**REMARKS**

**Summary of the Office Action**

**Summary of the Response to the Office Action**

FIG. 4

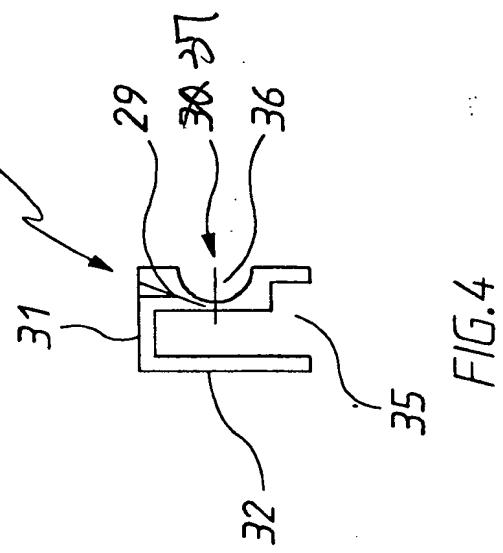
Drawings stand objected to because the designation of reference numeral 30 is improper in Figures 4 and 5, and the Final Office Action acknowledges the receipt of the corrected drawings filed on November 18, 2002. The Final Office Action states that a “proposed drawing

correction was not received and is required in reply to this Office Action.” Accordingly, Applicant submits herewith a Request for Approval of Drawing Changes proposing the same drawings changes as those in the Submission of Corrected Drawings filed on November 18, 2003 in the present application. In addition, Applicant submits herewith a Submission of Formal Drawings incorporating these proposed drawing changes. Accordingly, the Examiner’s approval of the changes made and withdrawal of the objection to the drawings are respectfully requested.
